UNITED STATES PATENT AND TRADEMARK OFFICE

APPLICATION NO.	FILING DATE	FIRST NAMED INVENTOR	ATTORNEY DOCKET NO.	· CONFIRMATION NO.
`	10/534,999	12/20/2005	Josef Wimmer	037068.53616US	1997
		12/20/2005 7590 10/03/2007 & MORING LLP 'UAL PROPERTY GROUP	1	EXAMINER	
INTELLECTUAL PROPERTY GROUP		AL PROPERTY GRO	JP	NGUYEN, XUAN LAN T	
	P.O. BOX 1430 WASHINGTO	•		ART UNIT	PAPER NUMBER
		,		3683	
					•
				MAIL DATE	DELIVERY MODE
				10/03/2007	PAPER

DETAILED ACTION

REPLACEMENT SHEET Crowell & Moring, LLP (202) 624-2500 Title: Disc Brake Having an Adjustment Device in Particular for a Commercial Vehicle First Inventor: Josef WIMMER Docket: 037068.56316US

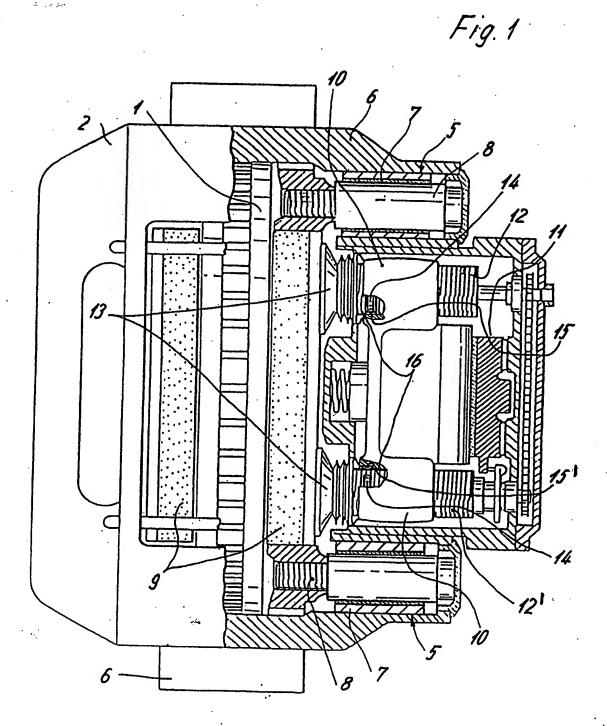
1. The drawings were received on 8/3/07. These drawings are approved.

epproved XLV 9/25/07

FIG. 4

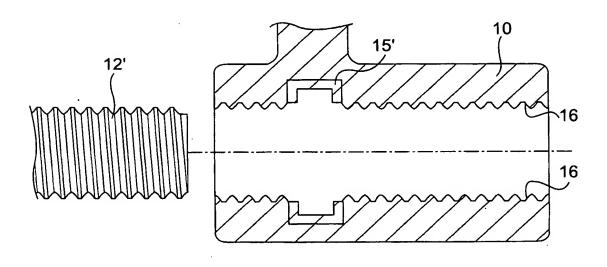
approved XLN 9/25/07
